**SUBJECT: PLANNED UNIT DEVELOPMENT
PERMIT NO. 11-000021 (PUD 11-000021)**
Project: "Big Island Country Club Estates"
Applicant: BICC Properties, LLC
Landowner: BICC Properties, LLC
**TMK: 7-1-007:001 to 050 and 7-1-008:001 to 012 Pu'uanaulu
Homesteads, North Kona District, Hawai'i**

TO: BJ LEITHEAD TODD, PLANNING DIRECTOR
FROM: DARREN J. ROSARIO, FIRE CHIEF
SUBJECT: PLANNED UNIT DEVELOPMENT APPLICATION (PUD 11-000021)
APPLICANT: BICC PROPERTIES, LLC
RE: BIG ISLAND COUNTRY CLUB ESTATES PROJECT
OWNERS: BICC PROPERTIES, LLC
TMK: 7-1-007:001 TO 050 AND 7-1-008:001 TO 012

EXHIBIT 10

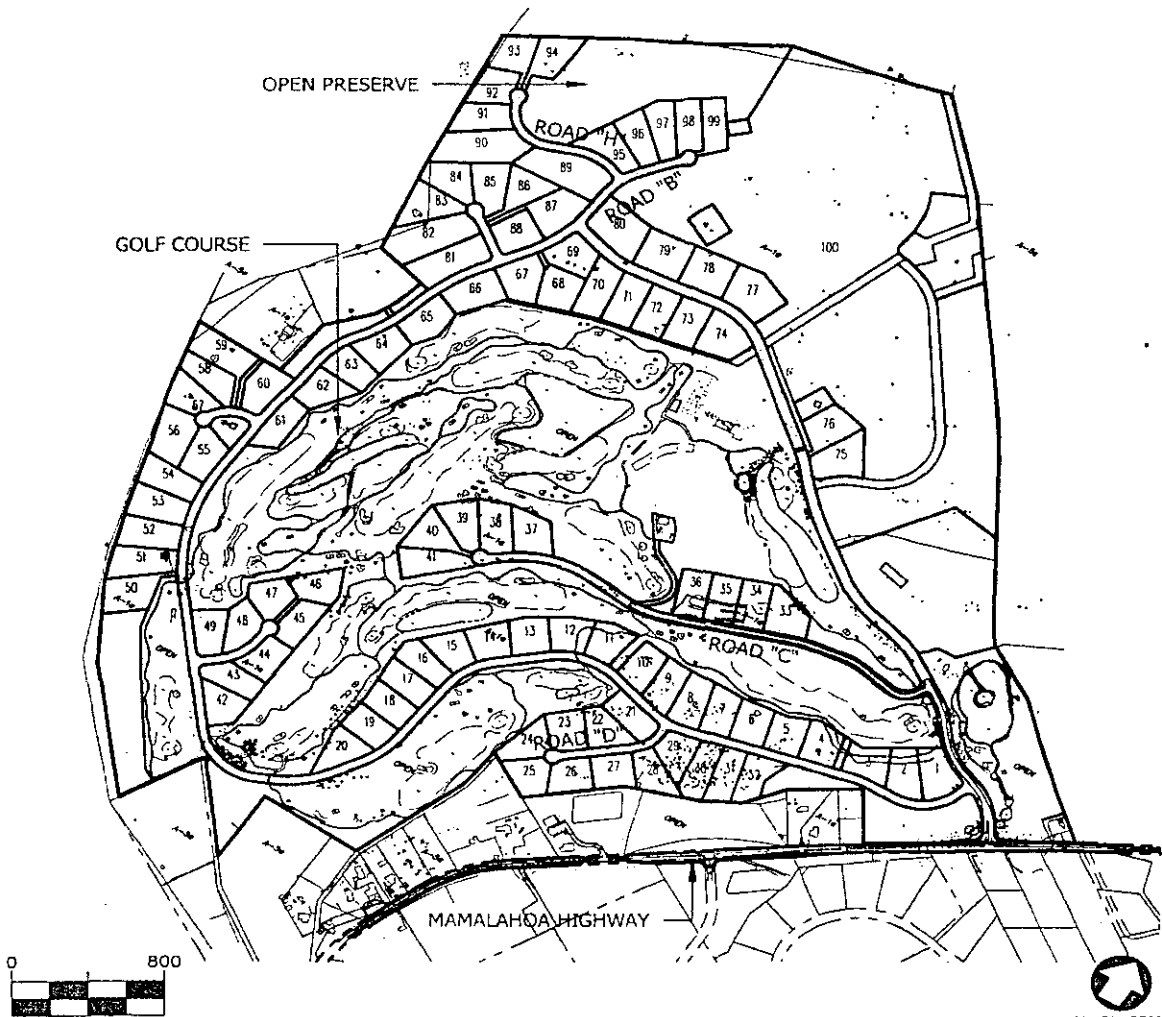
- **Cul-de-sacs** (Hawai'i County Code §23-48(a)). Applicant requests variance from the requirement that cul-de-sac shall be short as possible and shall not be more than six hundred feet in length nor serve more than eighteen lots. Based on the irregular shape, topography and existing configurations of the golf course, we have no objections to this variance since longer streets may be approved by the director when unusual conditions exist. No variance from the maximum 18-lot limit along cul-de-sacs is necessary since the Applicant's subdivision layout is compliant with this requirement. The deviations are limited to the exhibits as included within this PUD Permit.

Request:
The Petitioner requests that the requirements of 23-48(a) be modified to allow cul-de-sacs longer than 600 feet in length on the affected roads listed below.

- Affected Roads:**
Road "C" - 2580 feet, serves only 9 lots
Road "D" - 680 feet, serves only 8 lots
Road "B" - 730 feet, serves only 5 lots
Road "H" - 860 feet, serves only 6 lots

TYPICAL SECTIONS
50' PRIVATE ROW - ROADS "B" thru "H"
 SCALE 1/8" = 1'-0"

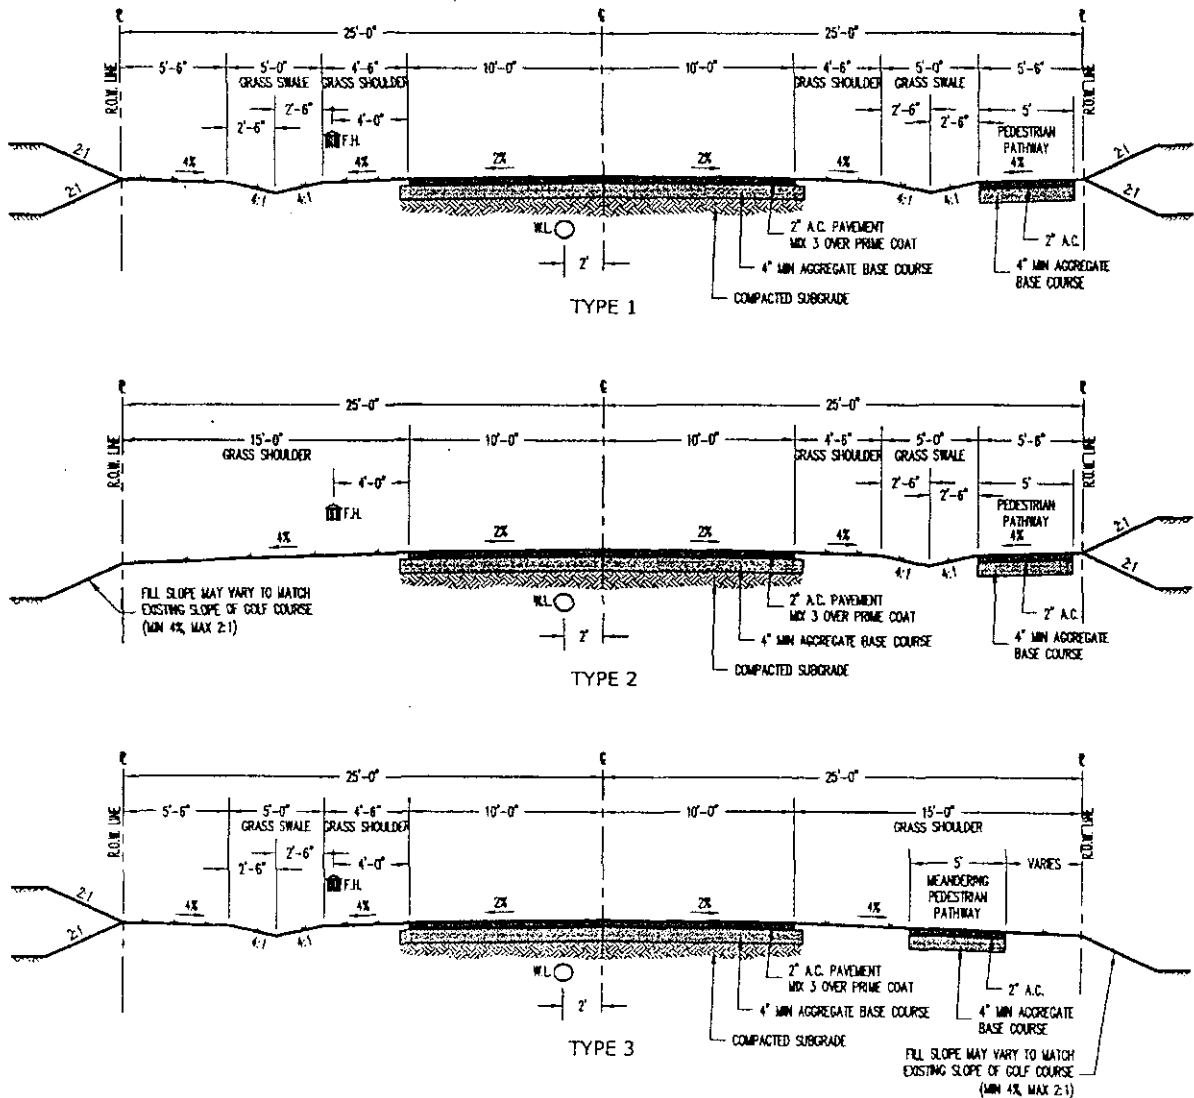
- **Roads "B" through "H"** having a pavement width of 20 feet with grass shoulder of a minimum width of 4.5 feet adjacent to the travel way, grass swale of 5 feet, a paved meandering pedestrian pathway of 5 feet, within a 50-foot right-of-way, having no curbs and gutters, and no on-street parking. **Refer to exhibit 11a.**

The Petitioner requests that the requirements of 23-41 be modified to allow a street with a right-of-way of 50 feet, pavement width of 20 feet, a grass shoulder of a minimum width of 4.5 feet adjacent to the travelway, a grass swale of 5 feet, a paved meandering pedestrian pathway of 5 feet, no curbs and gutters and no on street parking.

EXHIBIT 11c

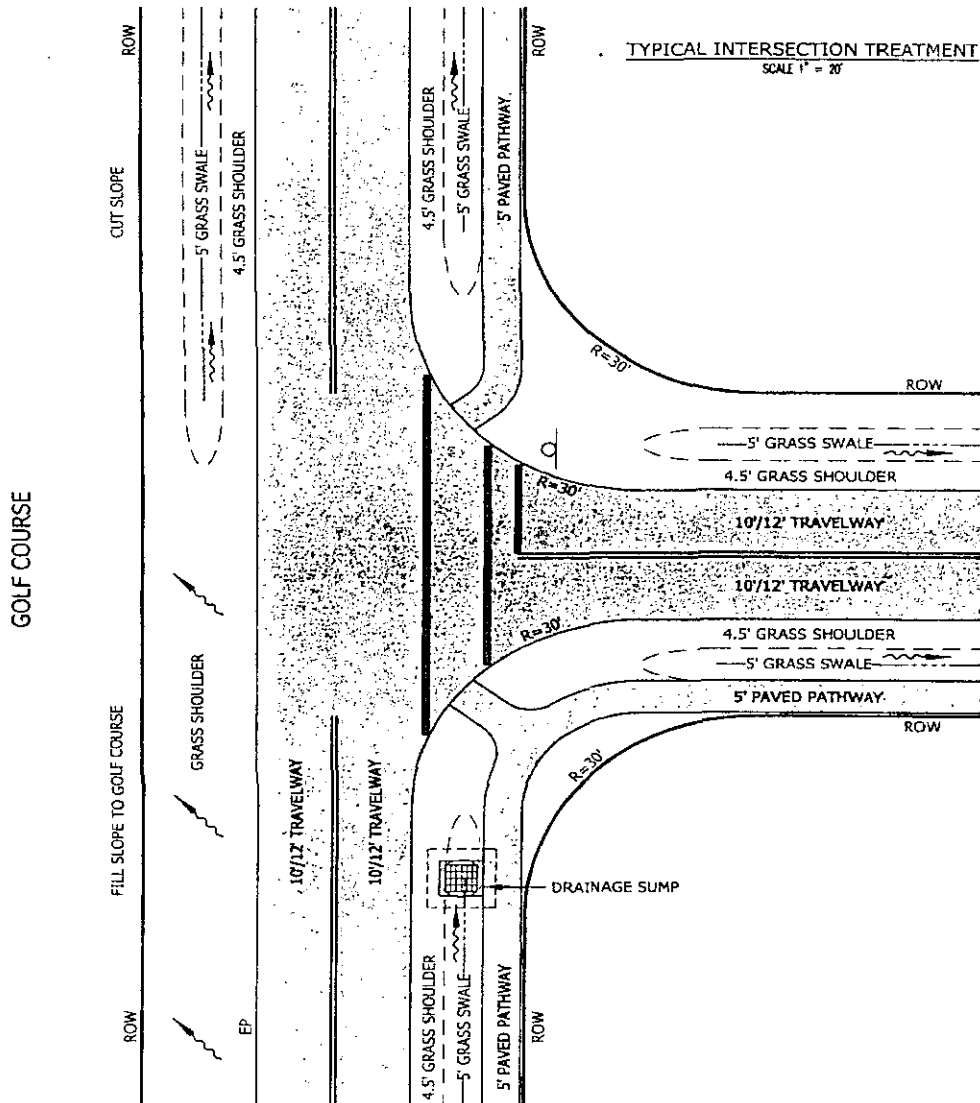
- **Project Entrance Treatment** to allow the Project entrance with grass shoulder of a minimum width of 4.5 feet adjacent to the travel way, a grass swale of 5 feet, a paved pedestrian pathway of 5 feet, with no curbs and gutters. **Refer to Exhibit 11c.**

The Petitioner requests that in conjunction with exhibits 5.1 and 5.2 that intersections be treated as pictured below. Having a grass shoulder of a minimum width of 4.5 feet adjacent to the travelway, a grass swale of 5 feet, a paved pedestrian pathway of 5 feet, no curbs and gutters.

EXHIBIT 11d

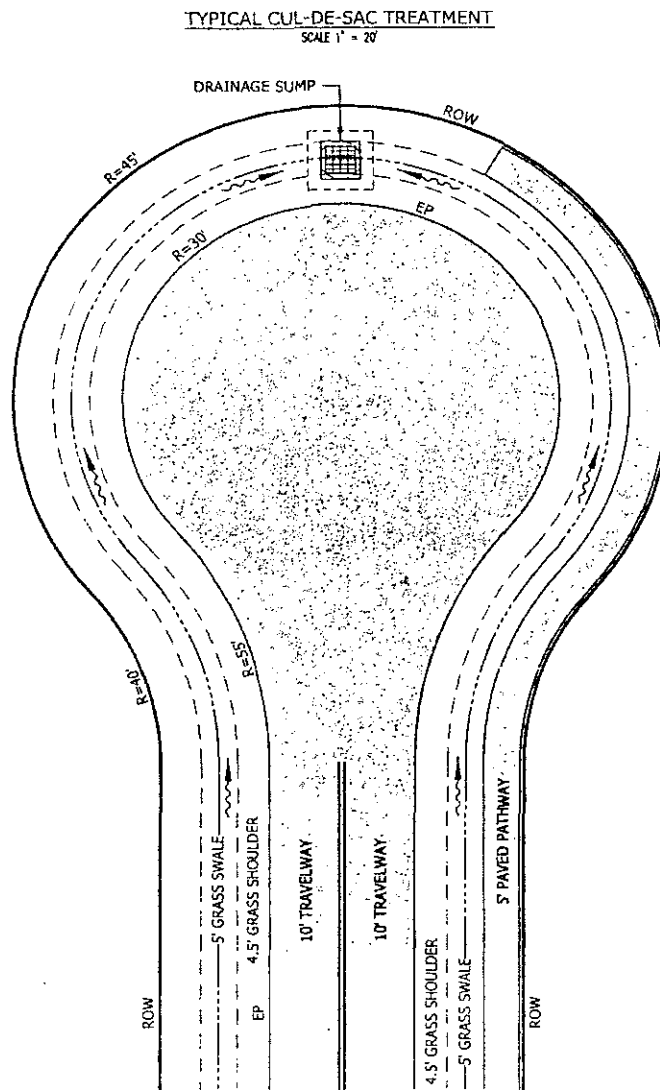
- **Cul-de-sac Treatment** to allow the cul-de-sacs within the Project with grass swale of 5 feet, a paved pedestrian pathway of 5 feet, with no curbs and gutters **Refer to Exhibit 11d.**

The Petitioner requests that in conjunction with exhibits 5.1 and 5.2 that cul-de-sacs be treated as pictured below. Having a grass shoulder of a minimum width of 4.5 feet adjacent to the travelway, a grass swale of 5 feet, a paved pedestrian pathway of 5 feet, no curbs and gutters.

EXHIBIT 12

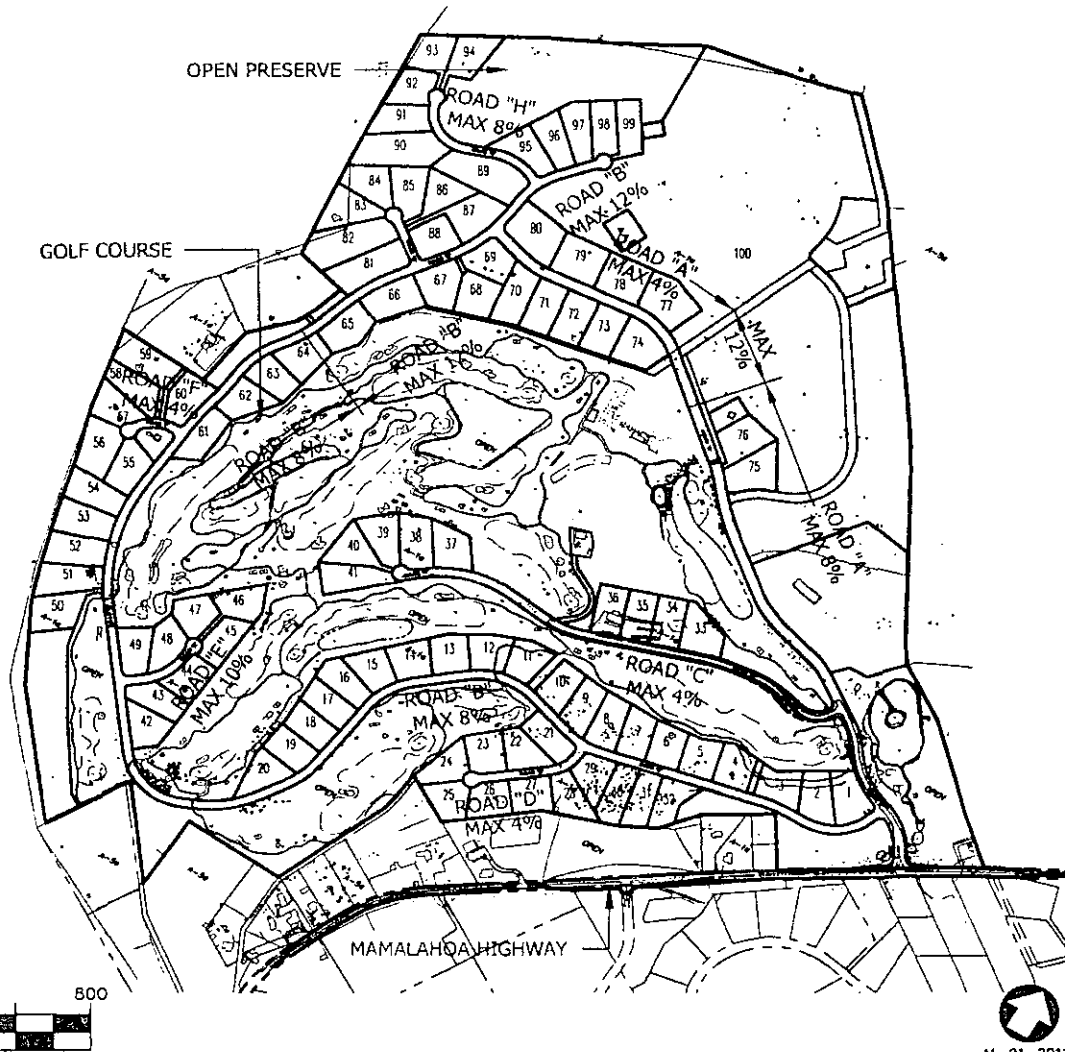
- **Grades and Curves** (Hawai'i County Code §23-50 (a). Applicant requested a variance from the minimum requirements for vertical and horizontal curves. This variance is approved on the basis of providing design flexibility in the presence of site constraints, but in a manner as generally represented in the Applicant's master plan. *In those instances where the vertical or horizontal curves do not meet the minimum requirements, the Applicant shall present alternate standards at the time of construction plan review, as provided for in §23-50(b), with lower design speeds assigned in order to meet the roadway safety standards as specified within the AASHTO Policy on Geometric Design of Highways and Streets, 2001.* The geometric design of the streets should be based on the AASHTO Guidelines for Geometric Design of Low Volume Roads (average daily traffic volume of less than 400 vehicle trips per day).

Request:
The Petitioner requests that the requirements of 23-50 be modified to allow a maximum of 12% grade on a collector street provided that a shoulder of minimum 4.5 feet be paved. See Exhibit 5.2, Typical Section Type 1 shoulder note.

Grades and Curves

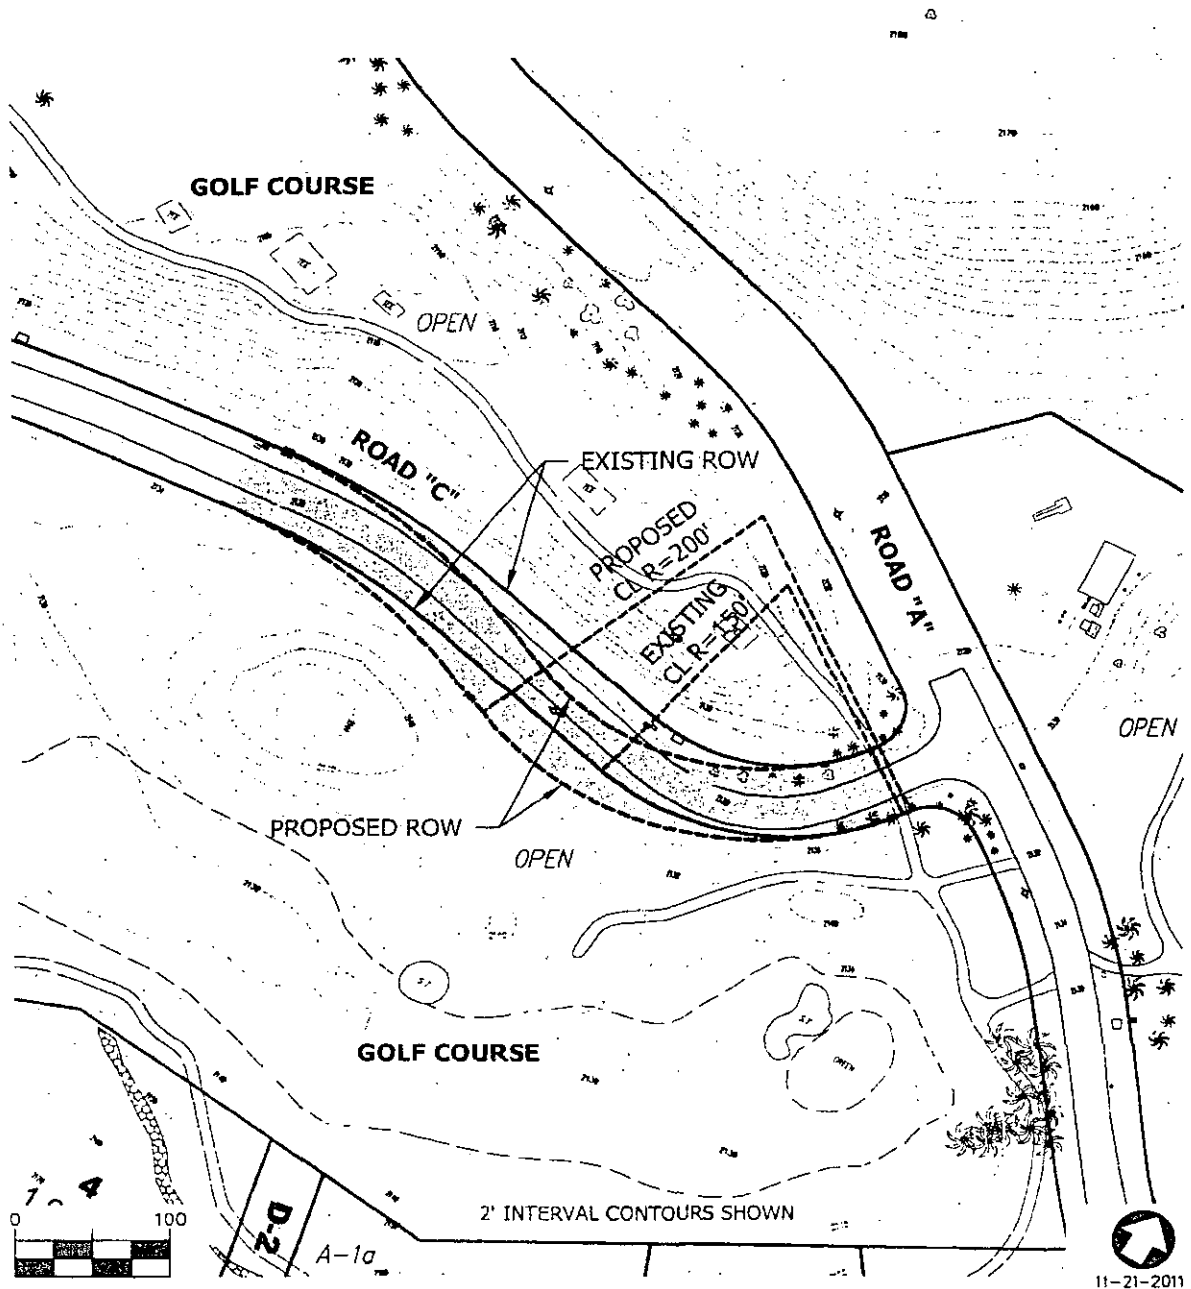
Exhibit showing the realignment of road "C" to accommodate a minimum horizontal curve of 200 feet.
